ARCHITECTURAL REVIEW COMMISSION AGENDA REPORT

SUBJECT: REVIEW OF TWO (2) SINGLE-FAMILY RESIDENCES AND ASSOCIATED SITE IMPROVEMENTS FOR A TENTATIVE PARCEL MAP (TWO-PARCEL FLEXIBLE LOT DESIGN SUBDIVISION), A FENCE HEIGHT EXCEPTION, AND A REQUEST TO REMOVE FIVE (5) TREES

FILE NUMBER: ARCH-0851-2025

PROJECT ADDRESS: 241 Hathway Avenue

Figure 4 – Proposed South and East Elevations for Parcel 1

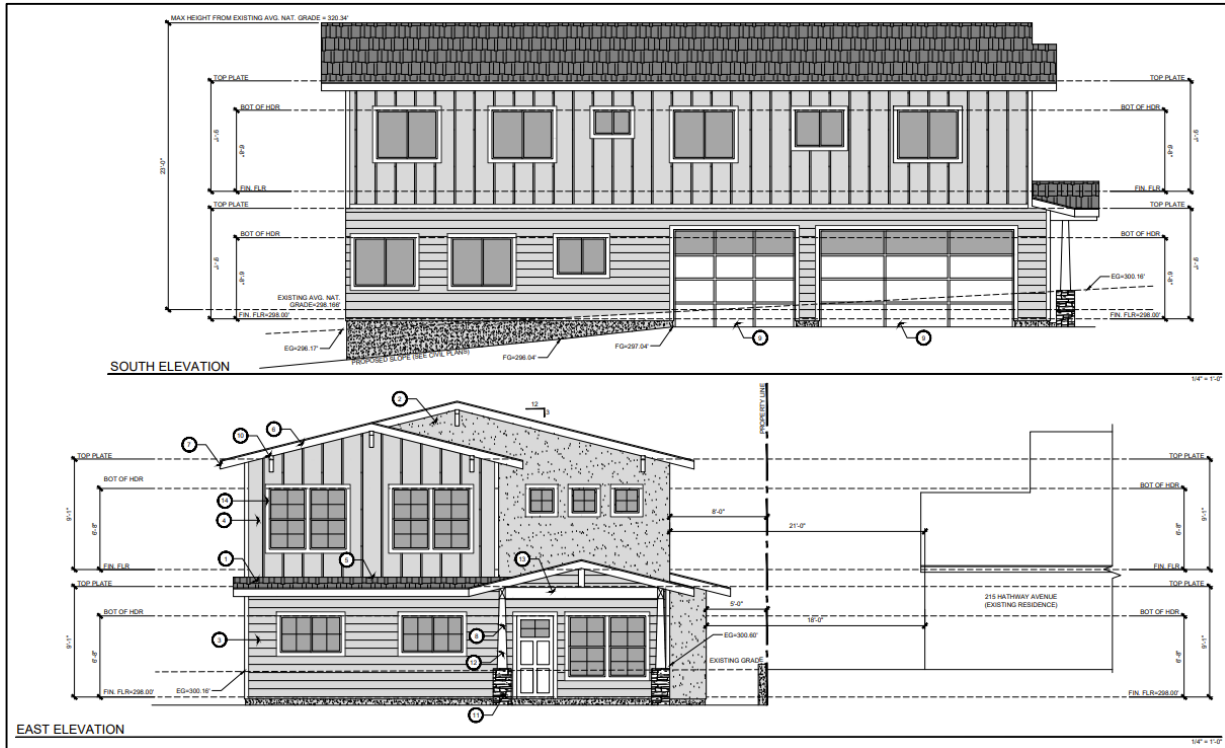
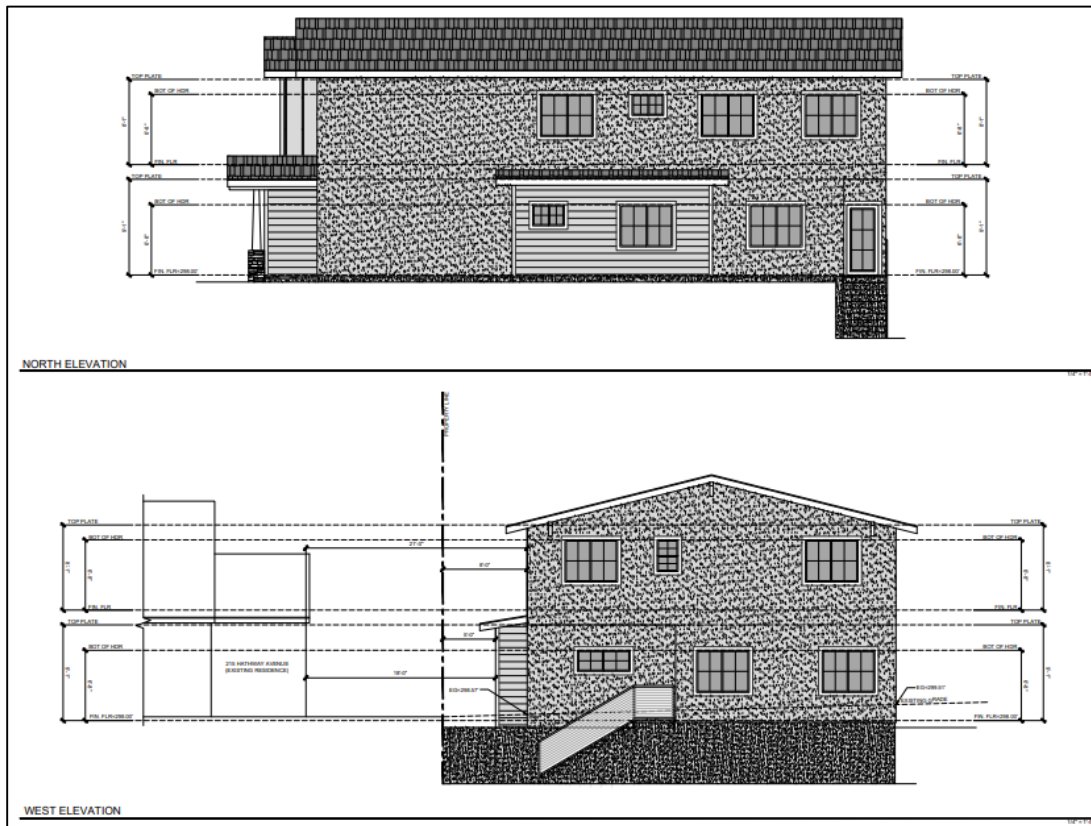
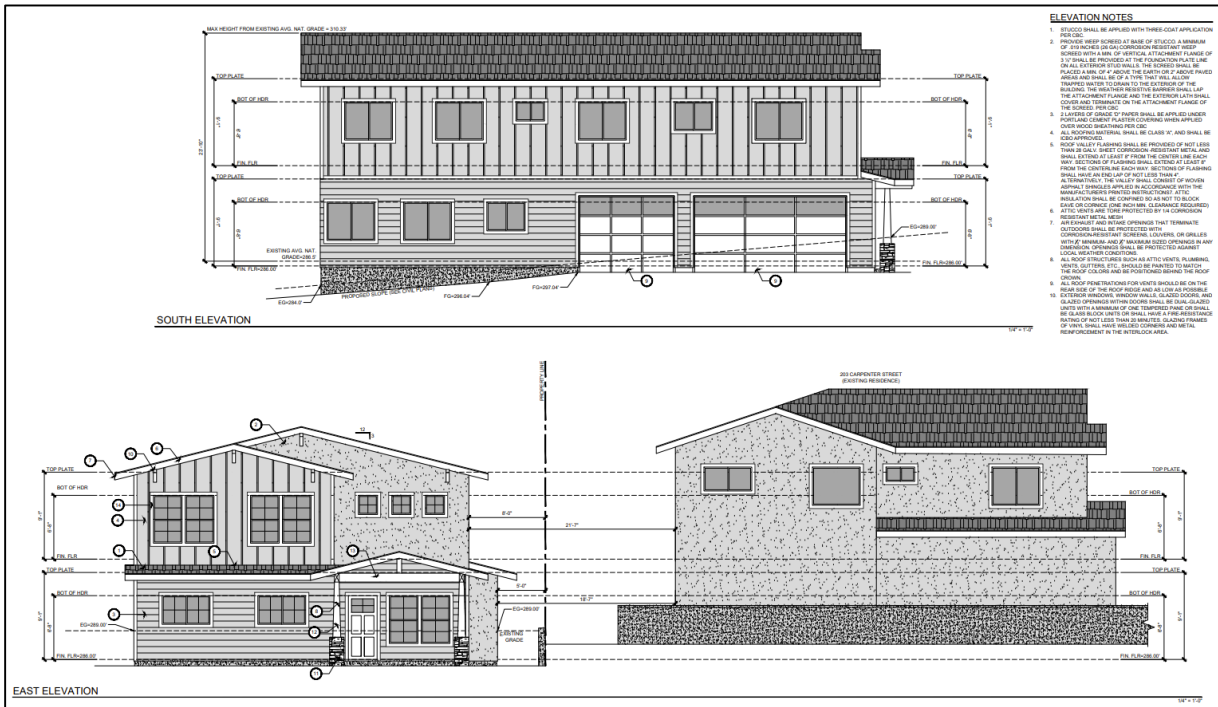
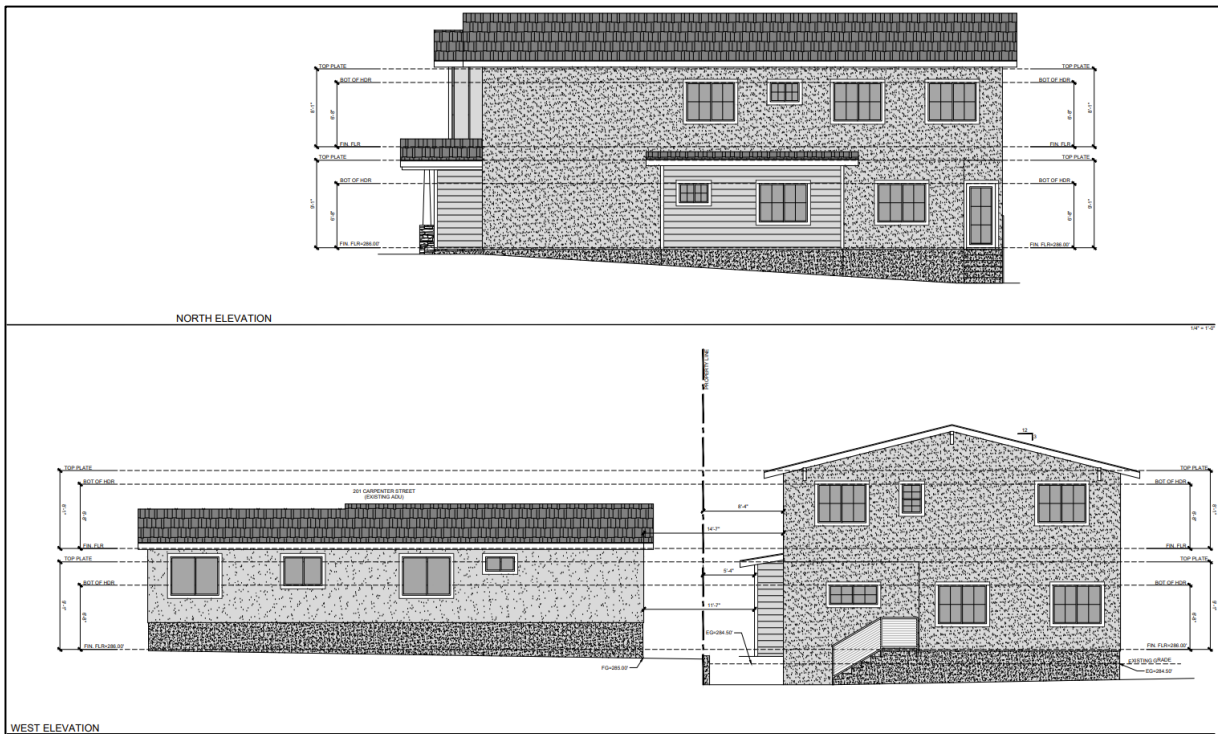
2.2(C) 5.5(A)(1)	Attention to detailing and emphasis on vertical and horizontal articulation are encouraged to visually reduce building mass. Houses in new subdivisions should incorporate a variety of detailing, size, and massing.	The project includes gable or hip roofs, windows with trim, and covered porches as design elements. <i>The ARC should discuss whether there is sufficient detailing and vertical and horizontal articulation to visually reduce building mass, particularly along the North and West Elevations for the proposed residences.</i>
CDG Section 5.2 Subdivision Design and General Residential Project Principles		
Highlighted Guideline	Brief Description of Guideline	Discussion

5.2(F)	Exterior finish materials should be durable and require low maintenance. The use of combined materials can provide visual interest and texture; however, all sides of the single-family residence should employ the same materials, design details, and window treatment.	The project utilizes Hardie board horizontal siding and batten siding, as well as stucco, and sliding windows with trim as exterior finish materials. <i>The ARC should discuss whether the proposed combination of materials provide sufficient visual interest and texture on all elevations for the residences.</i>
CDG Section 5.3 Infill Development

Figure 8 – Proposed Site Plan

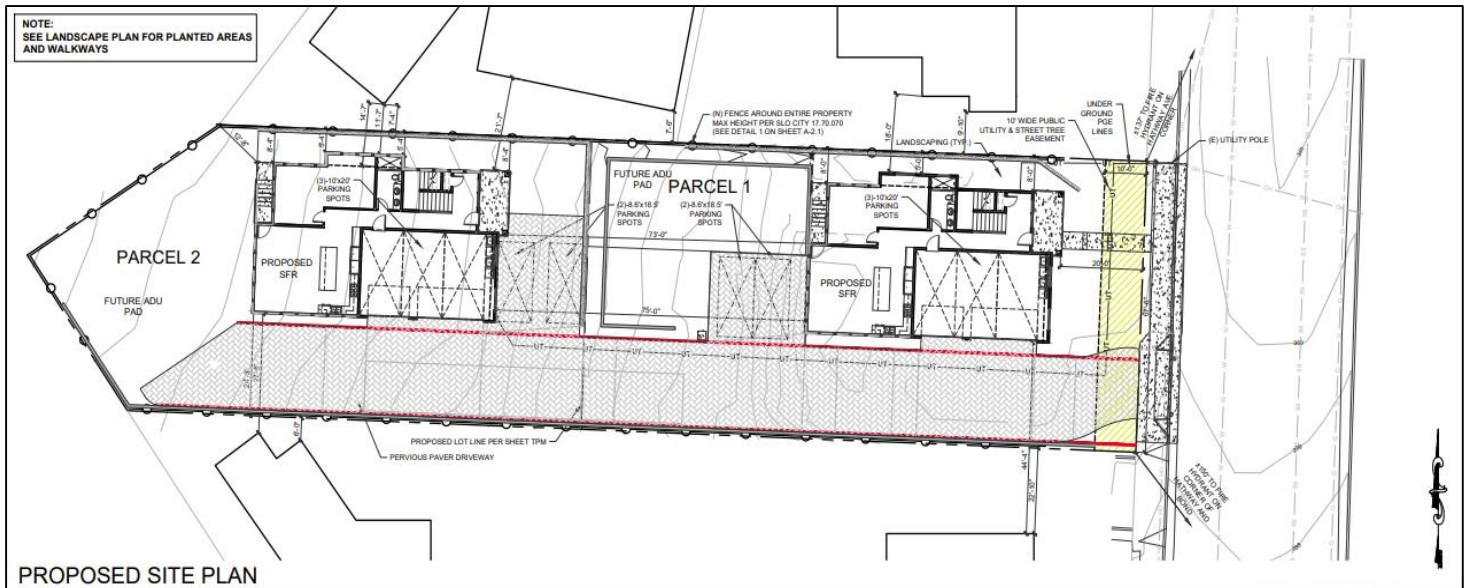
6.1(B)	Fences and walls can provide safety, security, screening, and privacy, but can also be unsightly because of their length and visibility unless well designed: <ul style="list-style-type: none"> - Design and placement should relate well to building architecture and topography. The elements should be the same quality in design and materials as the buildings. 	The project utilizes a wood fence and retaining wall combination that varies in height (maximum of nine [9] feet) along the site perimeter due to changes in topography. <i>The ARC should discuss whether wood fencing and retaining wall complements the design and materials of the residences and whether the requested fence height exception to allow a maximum height of 9 feet of the wood fence and retaining wall combination, where 6 feet is the standard, is consistent with or an improvement to the neighborhood and consistent with the CDG.</i>
